APPENDIX C

PEACHTREE CITY UNIT RETROFITS

Retrofits listed herein are required at all units of the same type, not just the units that were surveyed.

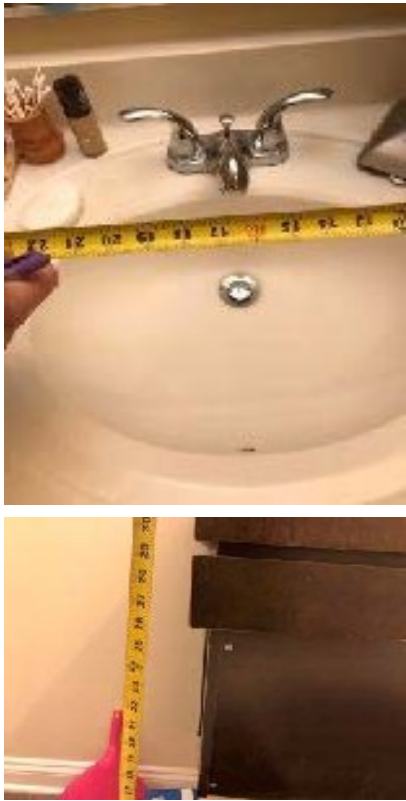
UNIT AL-DAFFODIL ANSI Tinsley ANSI / Tinsley	Surveyed Unit 211	
11		Sink centerline is 17 inches from side wall. No 30 inch by 48 inch clear floor space is provided at the sink for a parallel approach and sink base did not appear removable (30 inch by 48 inch clear floor space for either parallel or forward approach required).	Install removable base cabinet for forward approach or reduce wing wall to not extend beyond face of the countertop more than 1-½" for parallel approach to sink.

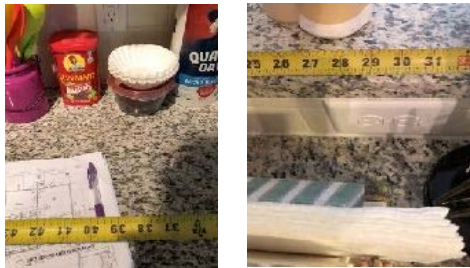
28		Toilet centerline is 15-3/4 inches from the sidewall (18 inches required).	Toilet centerline to be a minimum of 16" and a maximum of 18" from sidewall. Install offset flange to shift toilet or overlay sidewall with new finished surface such that toilet is a maximum of 18" from sidewall. Remove and reinstall grab bars as needed. New sidewall surface shall extend a minimum of 60" from the rear wall and a minimum of 42" from the floor.
29		Clear floor spaces at the showers are 44 inches long (minimum 30 inch by 48 inch clear floor space parallel to the fixture and flush with the control wall required).	Reduce depth of wing wall to provide minimum 32" passage to shower and to provide 30" x 48" clear floor space parallel to shower with maximum 1.5" offset.

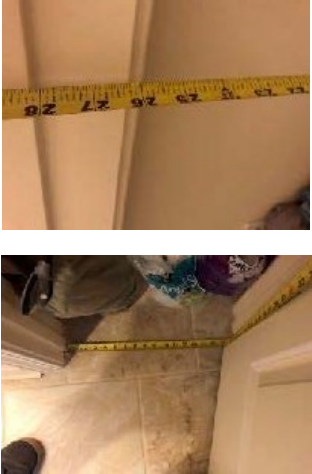
32		Clear floor spaces at the showers are 27-1/2 inches by 45-1/4 inches (minimum 30 inch by 48 inch clear floor space parallel to the fixture and flush with the control wall required).	Reduce depth of wing wall to provide minimum 32" passage to shower and to provide 30" x 48" clear floor space parallel to shower with maximum 1.5" offset.
	UNIT IL 2BR-A ANSI Elm - ANSI Type A	Surveyed Unit 108	
33	  	No accessible outlets are within reach range at the corner counter area (at least one accessible outlet with 30 inch by 48 inch clear floor space is required at each countertop area).	Relocate corner outlet to no less than 27" from the inside corner of the kitchen to the centerline of the outlet. The outlet location must be no more than 25 1/2" from the clear floor space for a parallel approach aligned with the countertop and free from obstructions.

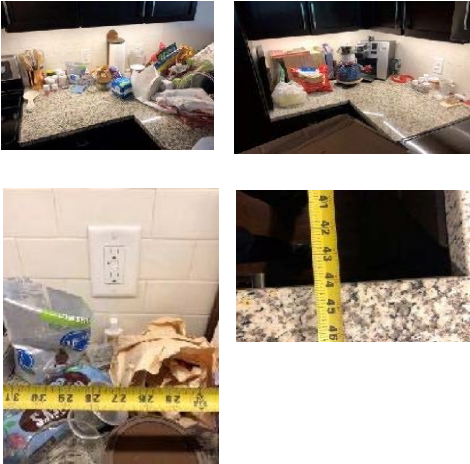
37		Clear floor spaces at the showers are 27-1/2 inches by 45 inches (minimum 30 inch by 48 inch clear floor space parallel to the fixture and flush with the control wall required).	Reduce depth of wing wall to provide minimum 32" passage to shower and to provide 30" x 48" clear floor space parallel to shower with maximum 1.5" offset.
	IL Unit 1BR-C2 Cypress	Surveyed Unit 125	
38		No accessible outlets are within reach range at the corner counter area (at least one accessible outlet with 30 inch by 48 inch clear floor space is required at each countertop area).	Relocate corner outlet to no less than 27" from the inside corner of the kitchen to the centerline of the outlet. The outlet location must be no more than 25 1/2" from the clear floor space for a parallel approach aligned with the countertop and free from obstructions.
